# Addendum Addenda

No./No  2
-----------------

Project Description / Description de projet <b>U-61 Asbestos Containing Fireproofing Removal and Cladding Replacement</b>		
Project No./No de projet <b>5698</b>	Departmental Representative / représentant ministériel <b>Benoit Huot</b>	Date <b>15 Dec 2020</b>
Solicitation No./N° de sollicitation <b>20-58082</b>		
Notice: This addendum shall form part of the tender documents and all conditions shall apply and be read in conjunction with the original plans and specifications.		
Nota: Cet addenda fait partie intégrale des dossiers d'appel; toutes les conditions énoncées doivent être lues et appliquées en conjonction avec les plans et les devis originaux.

PROJECT: PROJECT NO. = 5698  
BUILDING U-61 (UPLANDS CAMPUS)  
**U-61 EXTERIOR UPGRADES OF UPPER TARMAC CLADDING COMPLETE WITH FIREPROOFING ABATEMENT**

14 PARTIAL NORTH ELEVATION OF SOUTH WALL  
A07 1:50

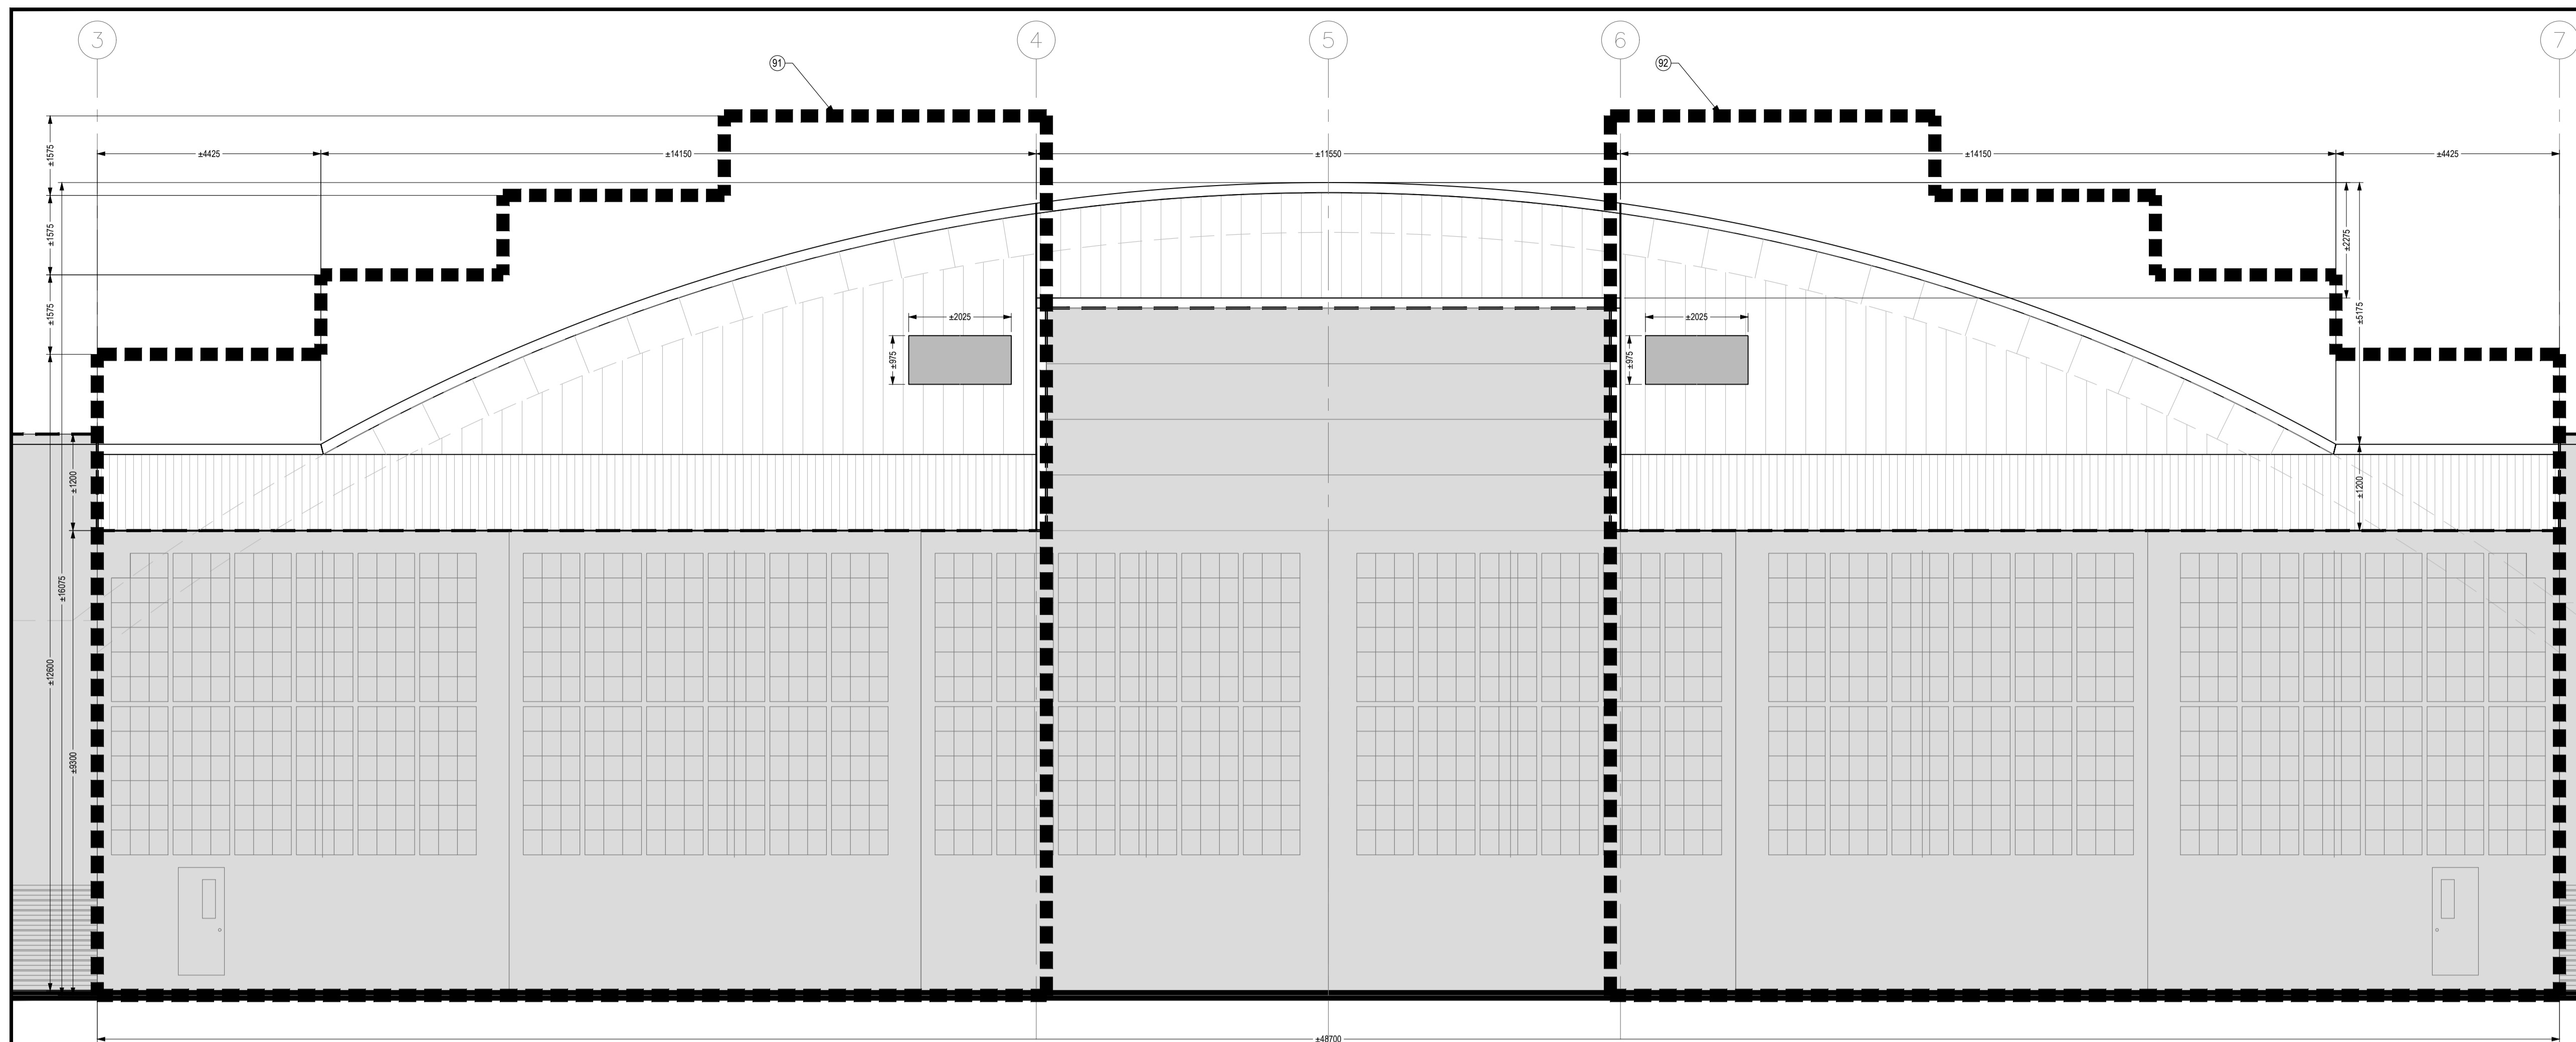
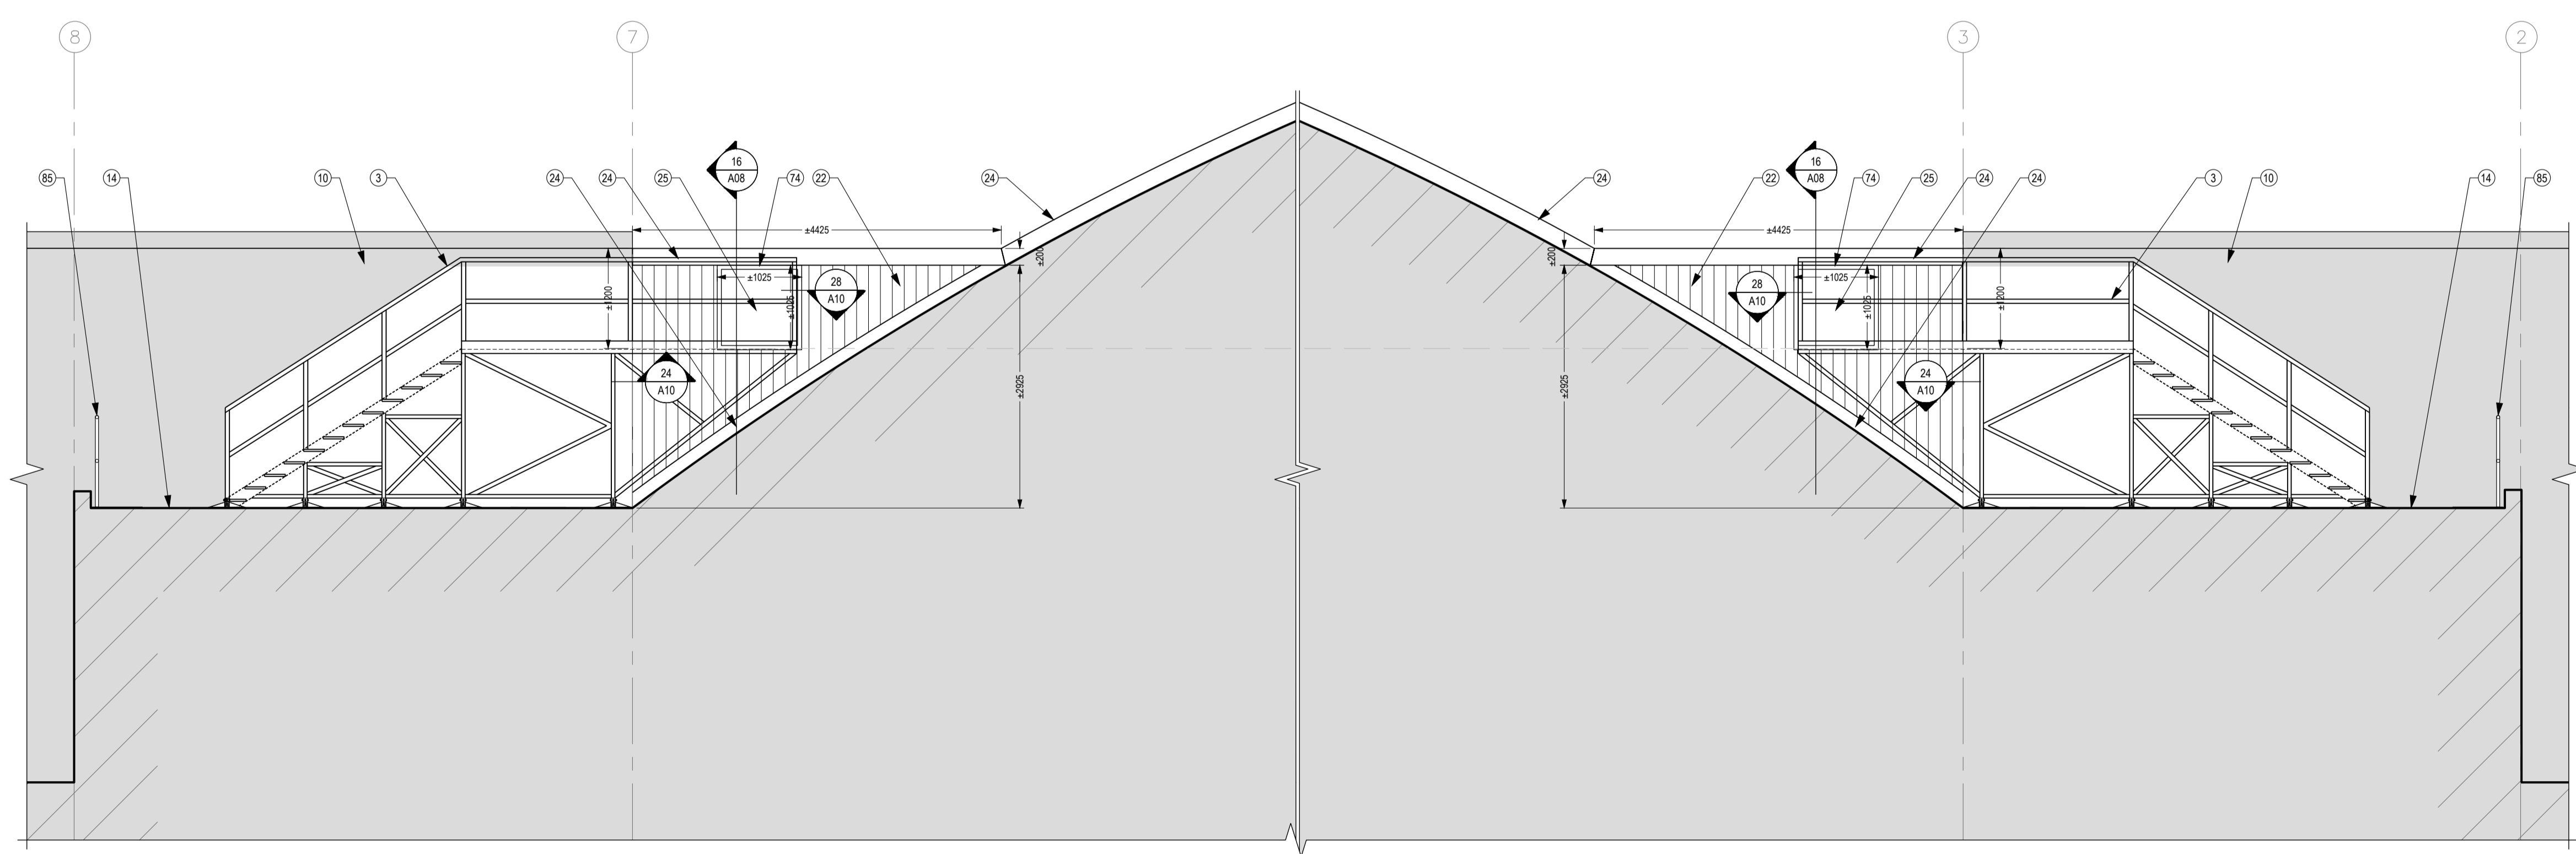
Architectural note 85 drawing 5698-A07 Please provide specification for guardrails & attachment to existing structure.

Please refer to the revised Section 05 52 00 – Modular Roof Guard-Platform Systems.
